Amendments to the Drawings:

Remarks/Arguments:

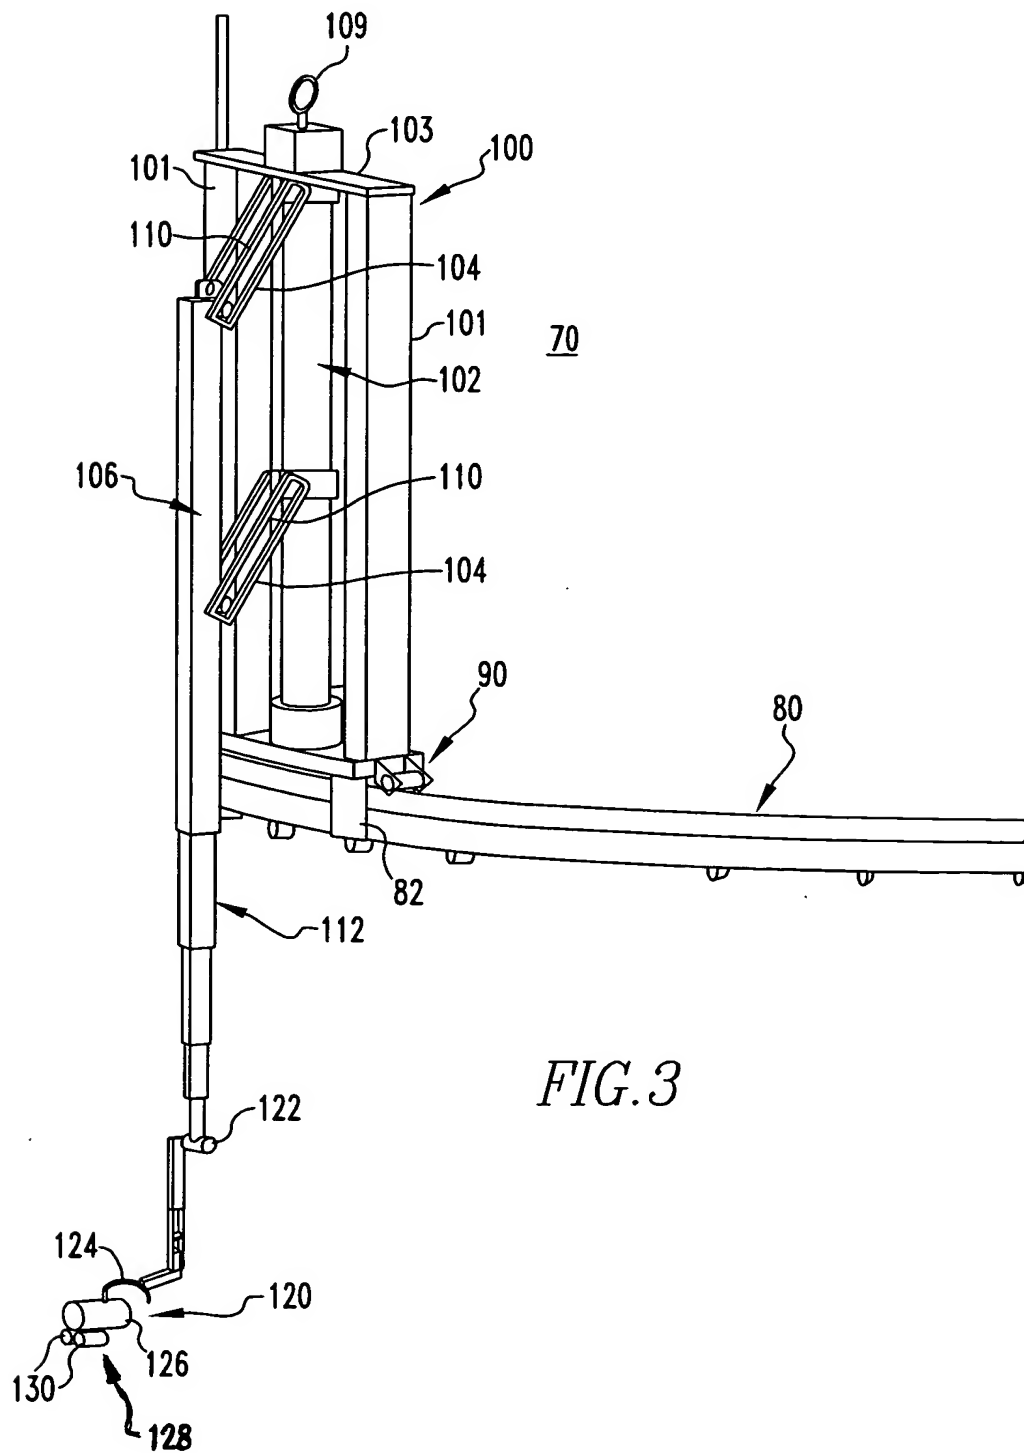
The attached sheets of drawings includes changes to Figure 3 and 7 that respectively insert a reference character in each of the amended figures without in any way changing the substance of the figures. These sheets, which include Figures 3 and 7, replace the original sheets including Figures 3 and 7. In Figure 3, previously omitted reference character 128 has been added and in Figure 7, reference character 86 has been added to specifically identify the cam previously shown in the drawing and described in the specification. A corresponding amendment has been made to the specification to include reference character 86 on the last paragraph on page 8.

In paragraph 3 of the Office action, the drawings were objected to under 37 CFR 1.83(a). The Examiner was of the opinion that the "remotely operated cam" was not shown in the drawings. Figure 7 has been amended to include reference character 86 which specifically identifies the remotely operated cam. Accordingly, the amendment to the drawing does not add any new subject matter, but clarifies where in the figure the remotely operated cam is illustrated. Corrected drawing sheets are appended hereto as the Attachment.
